REPORT TO THE CALGARY PLANNING COMMISSION

DEVELOPMENT PERMIT	ITEM NO: 9	
	CPC DATE:	2007 May 31
	DP NO:	DP2006-3199

PROPOSAL:
Apartment Building (229 residential units) with mixed use office and retail

NORTH ELEVATION &
WEST ELEVATION

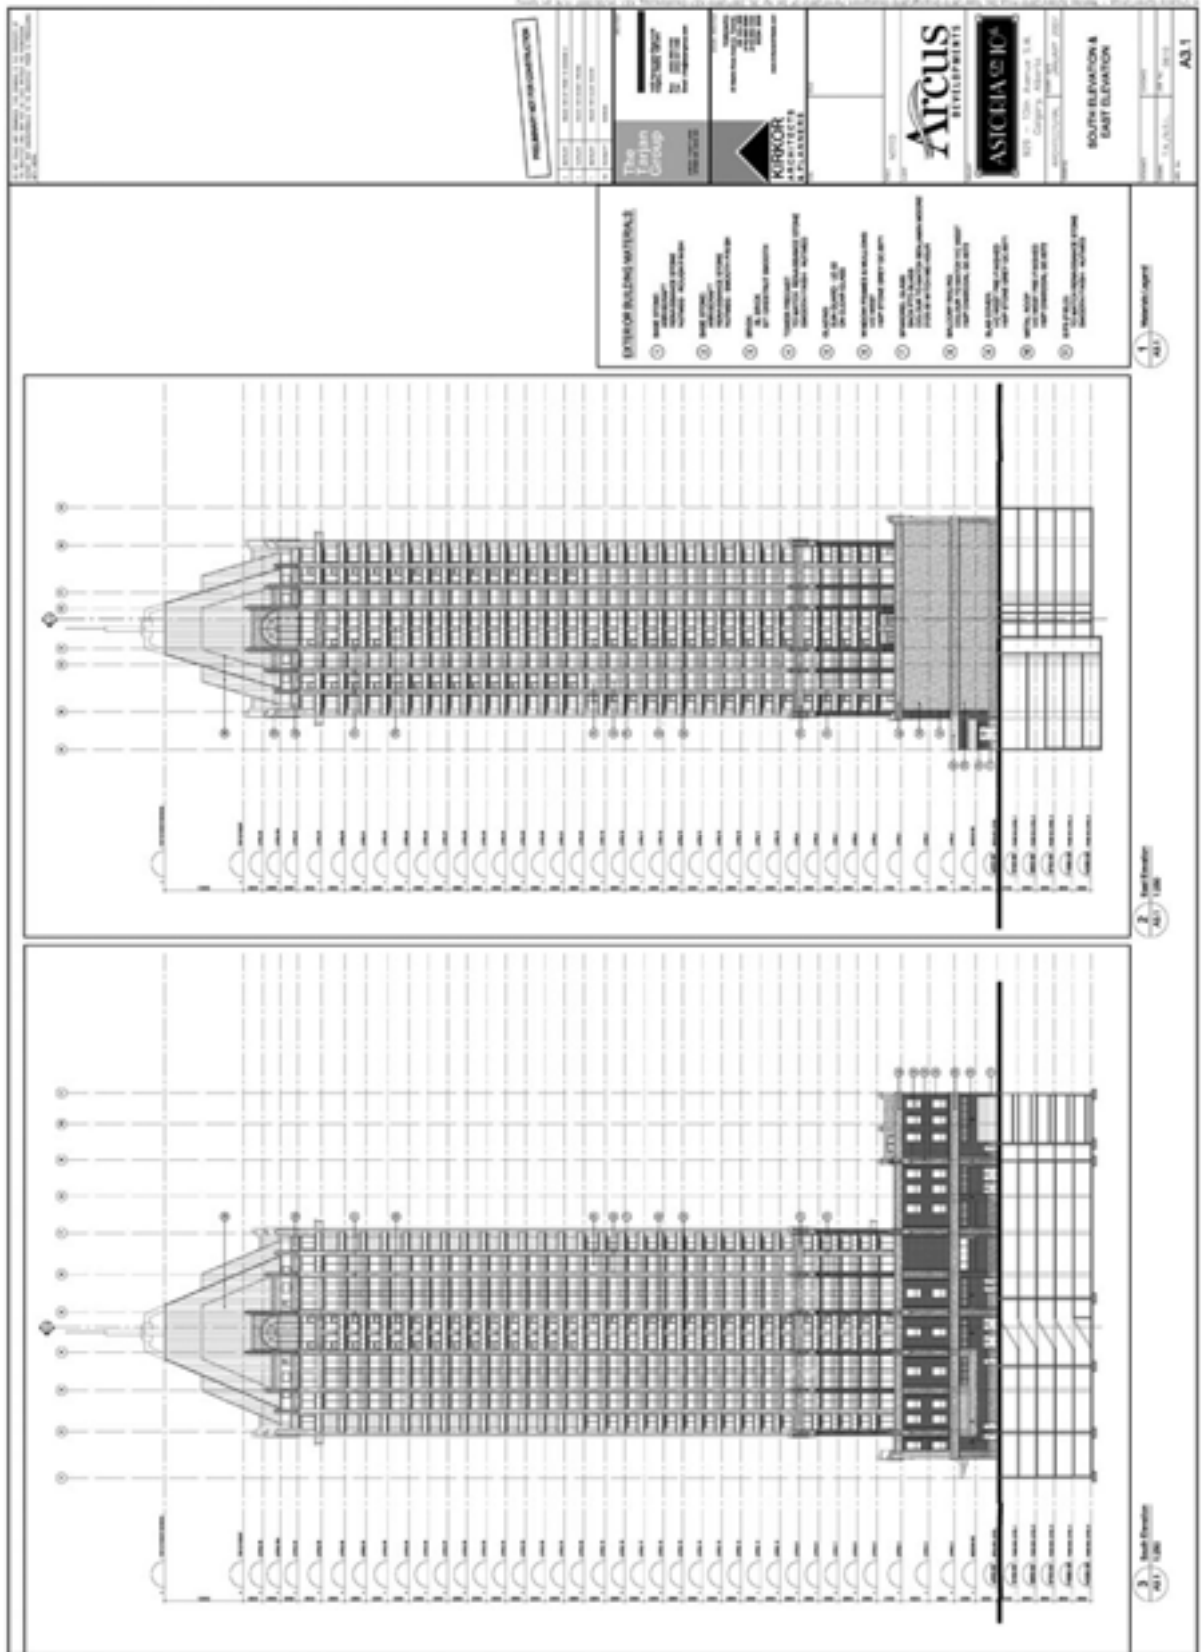
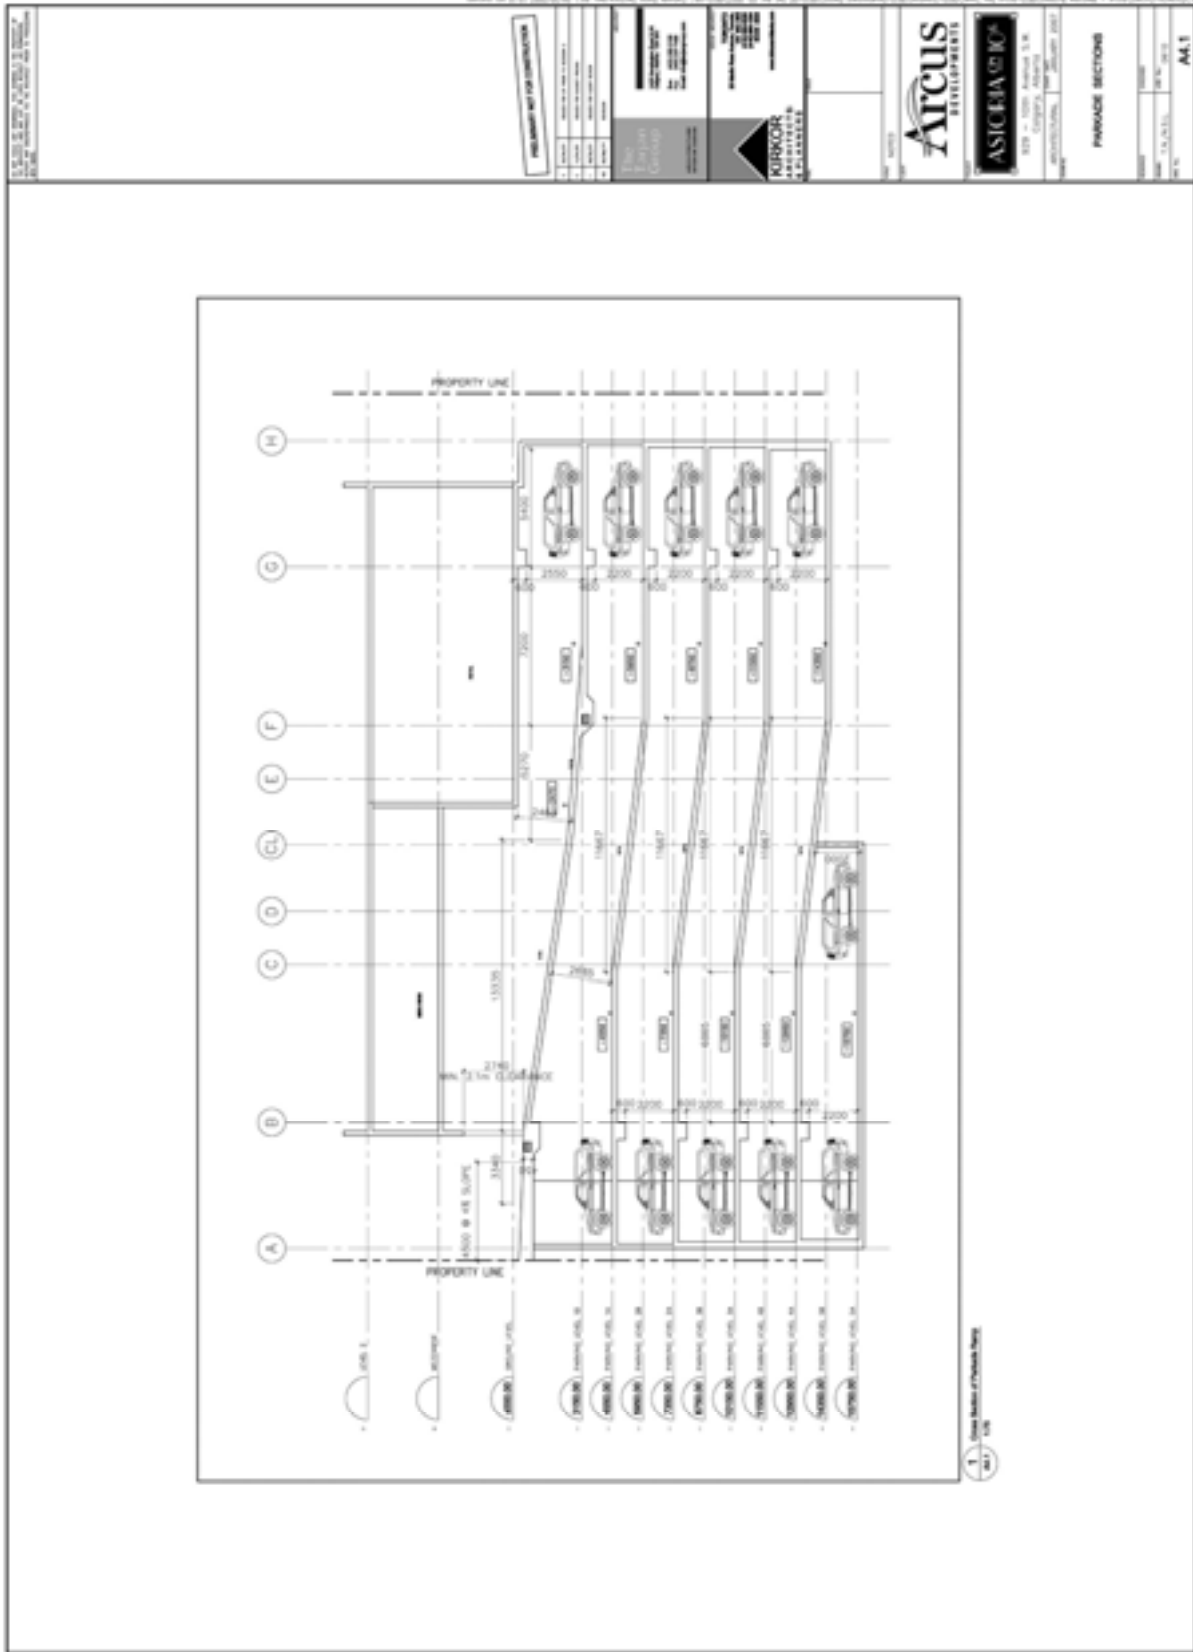
The Panel is concerned with the entry between the office tower and residential tower and the canopy and finds there is no differentiation from the commercial to the residential sections; and	PTR condition added to differentiate the commercial entrances from the residential entrance
The Panel commends the applicant for the changes that were made to the project and the clearness of the font size on the plans	Noted

4. Provide an 8 ½ X 11 inch colour and materials board that corresponds to the materials and colours listed on all elevations;
5. As per the UDRP comments revise canopy designs to differentiate residential from commercial entrances;
